14 SUPERIOR COURT OF THE STATE OF CALIFORNIA

**Case No. RCV RS 51010**

**DECLARATION OF PETER KAVOUNAS  
IN SUPPORT OF CHINO BASIN  
WATERMASTER'S MOTION FOR  
COURT APPROVAL OF UPDATE TO  
WATERMASTER SAFE YIELD RESET  
METHODOLOGY**

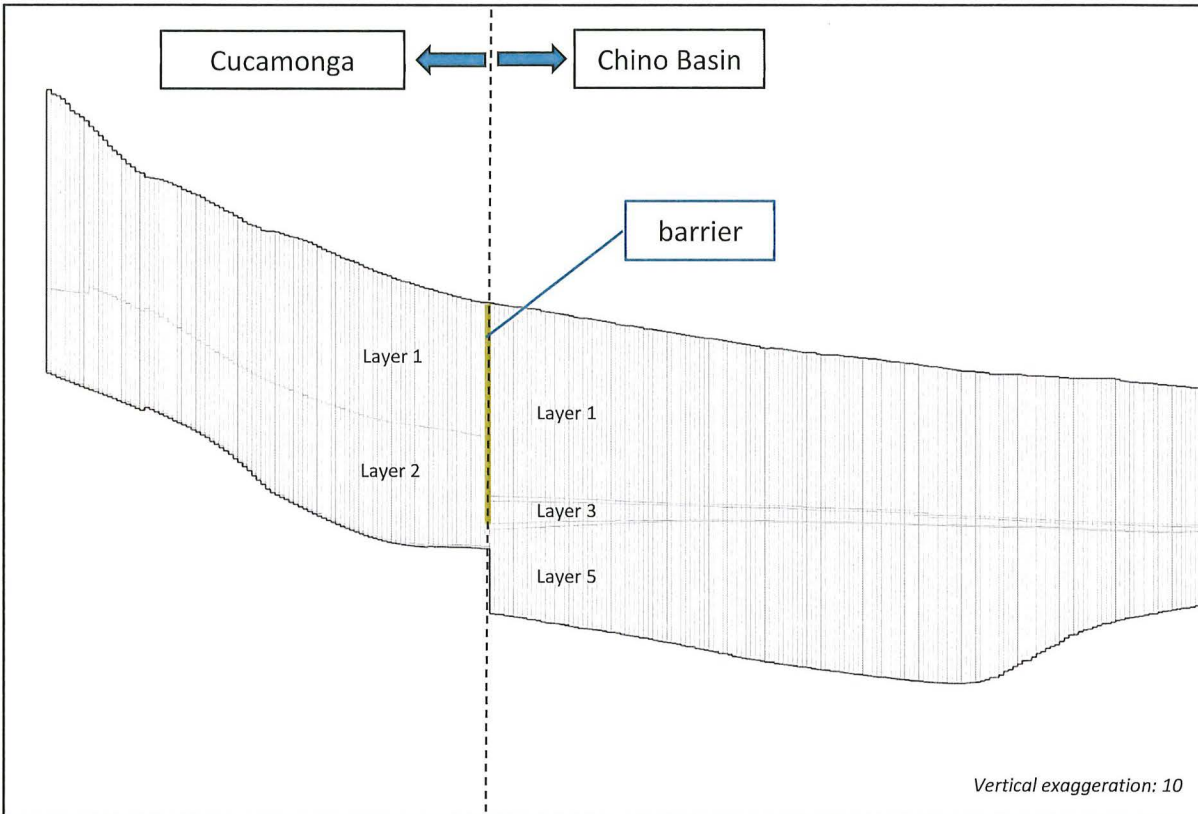
**Comment/Question 8:** On this [Cucamonga] part of the model did you maintain the layering that you had in the main Chino Basin or do you have different layering? [How] did you meld it up to the current larger [Chino Basin] model?

**Response:** *Cucamonga and Six Basins are considered to be hydrogeologically separated from the Chino Basin and the hydrostratigraphy (layering) is different than the Chino Basin. The connections to Chino Basin from the Cucamonga and Six Basins are simulated as barriers. The deep aquifers in Cucamonga and Six Basins will be modeled as weakly connected to Chino Basin's deep aquifer-system by using the barrier's hydraulic conductivity parameter. See figure depicting a cross-section of the model below.*

Mean Residual Error of Calibration Wells -- Updated

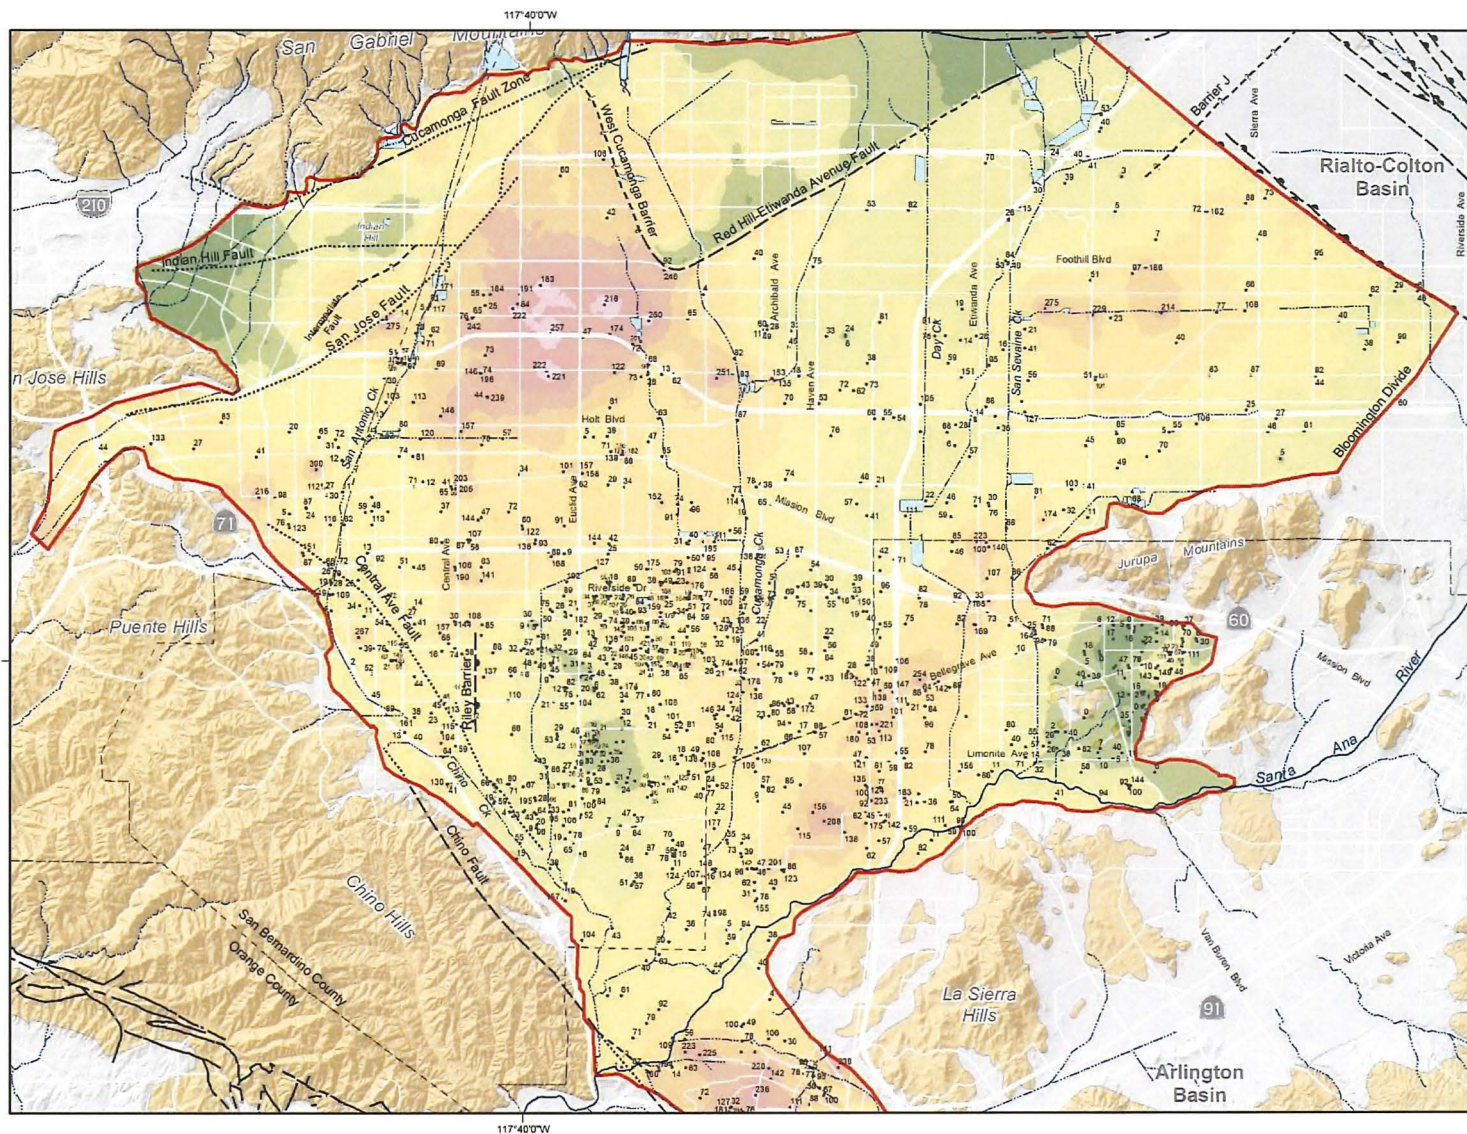
Mr. Rees and M. Coulibaly: *Figure 6-11 shows that Cucamonga Basin and Six Basins have all negative residuals, which implies that the 2020 Model over-predicts water levels in these areas. Please provide an explanation of the reason for this spatial bias and any implications for the Chino Basin.*

WEI response: Figure 6-11 shows only residual statistics for the Chino Basin and well locations in the other basins. This figure has been updated to include the mean residual for all of the basins; it is included herein as Figure 5. We acknowledge the appearance of the bias along the boundary of the Six Basins and Chino Basin. The wells in the Six Basins and Chino Basin near the San Jose Fault are perforated across multiple model layers, and the model-estimated groundwater level is influenced by the head in each layer. It is difficult to draw a definitive conclusion from the comparison of mean residual trends across the San Jose Fault. The slight over-prediction in the Six Basins and under-prediction in Chino Basin implied in Figure 5 suggests that subsurface inflow from the Six Basins to the Chino Basin could be higher than would occur if there was less or no bias. That said, the subsurface inflow from the Pomona Basins area of the Six Basins is a relatively small recharge component to the Chino Basin—about 2 percent of annual recharge to the Chino Basin in the projection period—and the effect of the apparent bias on subsurface inflow would be a fraction of that.

Figure 10  
Comparison of Simulated and Measured Water Levels in the Wells of Chino Basin

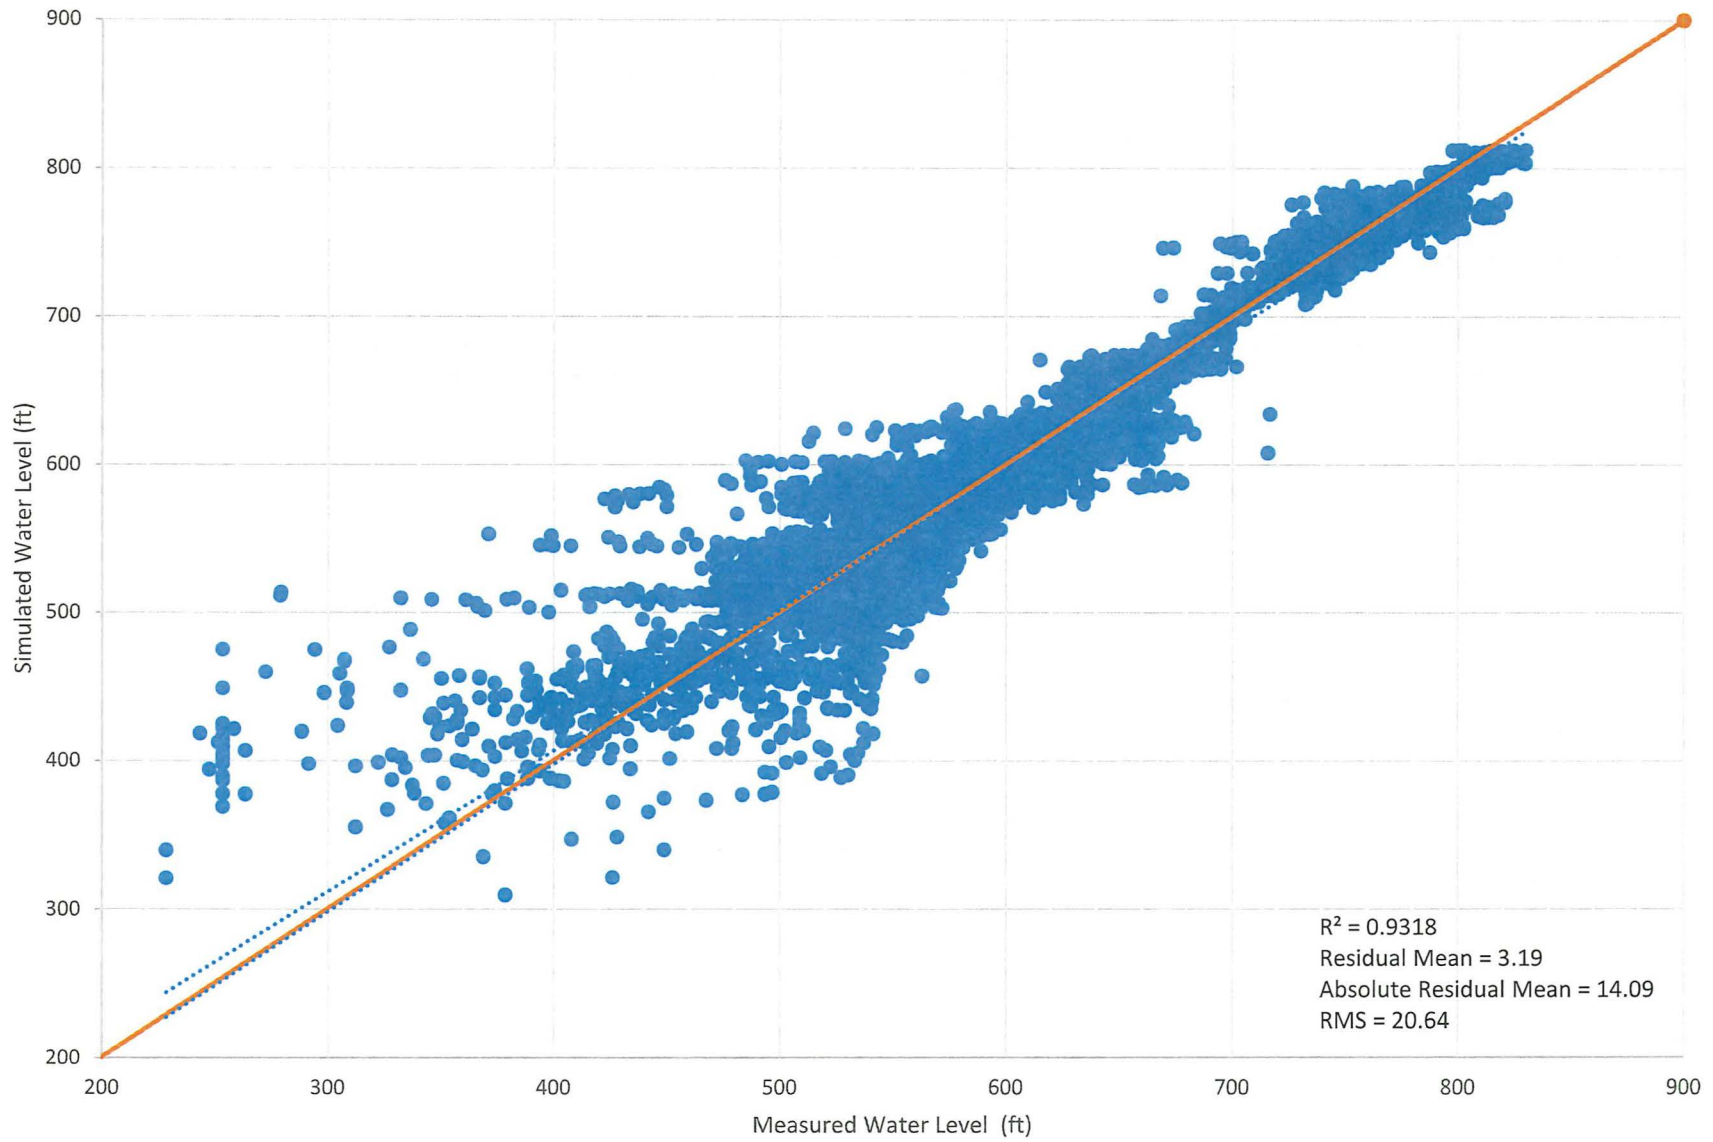
Mr. Rees and M. Coulibaly: *Figure 6-7 a-b: the  $R^2$  does not provide a comprehensive measure to assess the goodness of fit for calibration; the statistics requested in comment 4-b should be displayed on these graphs.*

- (a) Figure 6-7a seems to show that the model does not calibrate particularly well to the lower water levels (funnel shape residual distribution), even without the Chino Hills wells. Please explain this discrepancy and describe the effect it has on the overall model.
- (b) Figure 6-7c, of simulated and predicted water levels in the Six Basins, shows that the model misses groundwater level trends, which are key metrics for assessing model calibration, especially for prediction of future changes. Please explain this mismatch and any effect the quality of calibration in Six Basins may have on predicted underflow to the Chino Basin or other aspects of the overall model.

WEI response: We have included the requested statistics on Figures 6-7a-b; they are included herein as Figures 10 and 11, respectively, and for all basins in the 2020 CVM, listed in Table 3.
